AGENDA
July 17, 2013
Historic Preservation Committee
Regular Meeting

**STAFF REPORT TO THE HISTORIC PRESERVATION COMMISSION
PLANNING, ZONING, AND BUILDINGS DEPARTMENT**

Project Name: Certificate of Appropriateness for New Construction

Application: HPC 2013-3

FIGURE 16.16.220.04
INTERIOR LOT WITH NO STREET FRONTAGE

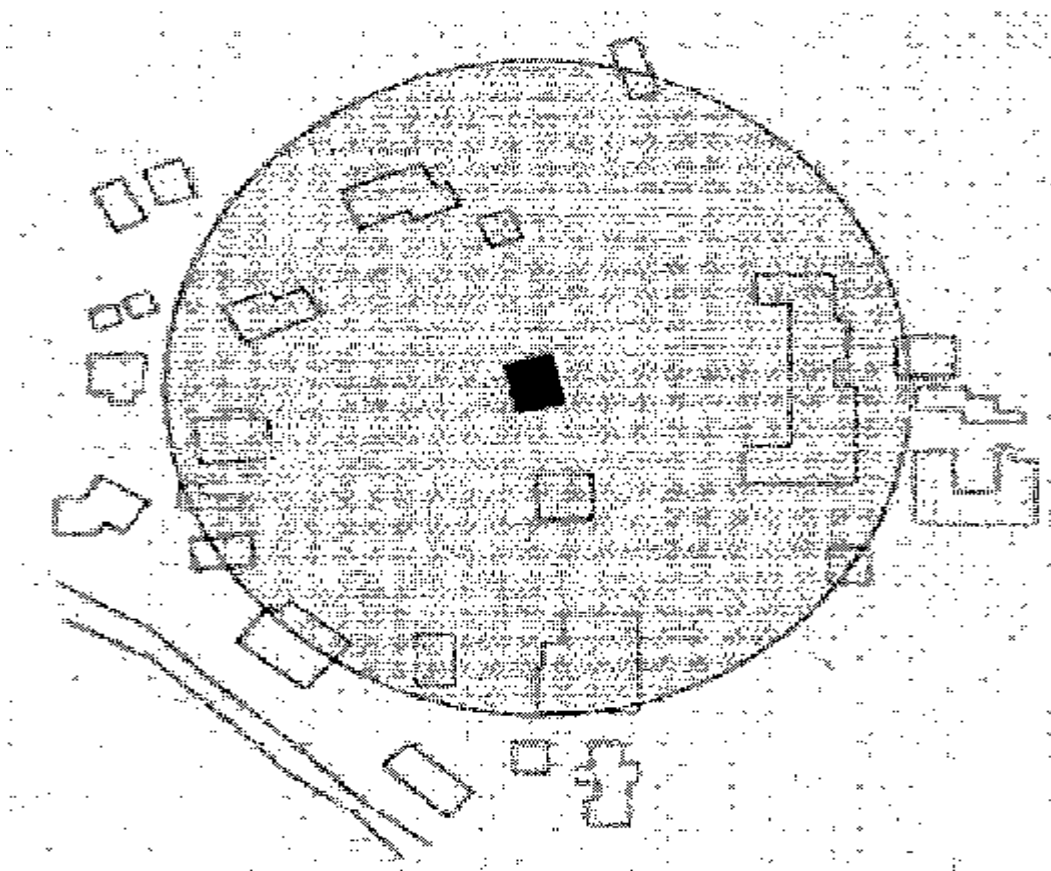
The Applicant's Agent has not submitted any documentation as part of this Certificate of Appropriateness request for the proposed new construction to demonstrate compliance with this criterion. The streetscape as defined for the proposed project is determined from section 16.16.220.6 subsection (B)(1)(d) which states “When the proposed new construction is located on a lot with no frontage on rights of way, the streetscape is defined by measuring a distance of three hundred feet (300') in all directions beginning from the midpoint of the facade which contains the principal entrance of the building. The height of a proposed yard wall or fence shall not exceed six feet (6')”. Below is the figure 16.16.220.04, "Interior Lot With No Street Frontage", from the LUDC which will assist the applicant in complying with this requirement.

Therefore as a condition of approval of this request, Staff will require that the Applicant submits documentation at the final public hearing to demonstrate compliance with this criteria.
